Access Compliance Report

Public Rights-of-Way

Intersection ID: 7091	Main Street: BROOKSHIRE_BV	Cross Street: HOVIS_RD	Location:	E
ADA ID: B52023F0A38F	Ramp Type: Perp	Initial Pass/Fail: Fail	Overall Compliance: No	Severity Score: 8.75

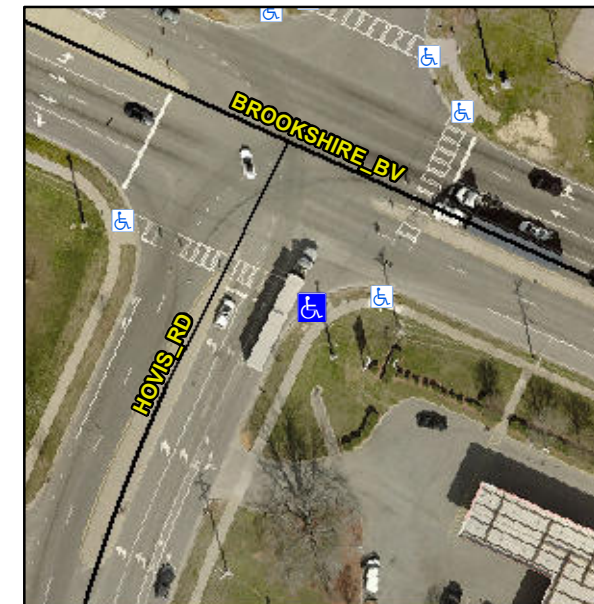
R304.5.1

Compliance	Description	Data	Compliance	Description	Data
N/A	Ramp Length (in)	87.0	Yes	Ramp Slope (%)	8.0
No	Ramp Width (in)	42.5	Yes	Ramp XSlope (%)	2.0
N/A	Flare Type LT	N/A	N/A	Flare Type RT	N/A
N/A	Flare Slope LT (%)	N/A	N/A	Flare Slope RT (%)	N/A
N/A	Flare Traversable LT?	N/A	N/A	Flare Traversable RT?	N/A
N/A	Landing Length (in)	N/A	N/A	DWS Provided?	N/A
N/A	Landing Width (in)	N/A	N/A	DWS Contrast?	N/A
N/A	Landing Slope (%)	N/A	N/A	DWS Length (in)	N/A
N/A	Landing X Slope (%)	N/A	N/A	DWS Full Width?	N/A
N/A	Landing Curb? (Y/N)	N/A	N/A	DWS Offset (in)	N/A
N/A	Shared Landing?	N/A			
N/A	Gutter Ponding?	N/A	N/A	Gutter Slope (%)	N/A
N/A	Gutter Lip Ht (in)	N/A	N/A	Gutter X Slope (%)	N/A
N/A	Painted X Walk1?	No	N/A	Painted X Walk2?	N/A
	X Walk 1 Direction	To NW		X Walk 2 Direction	N/A
N/A	X Walk 1 Width (in)	N/A	N/A	X Walk 2 Width (in)	N/A
	X Walk 1 Slope (%)	0.3		X Walk 2 Slope (%)	N/A
	X Walk 1 X Slope (%)	1.2		X Walk 2 X Slope (%)	N/A

Remove & Replace Entire Ramp.
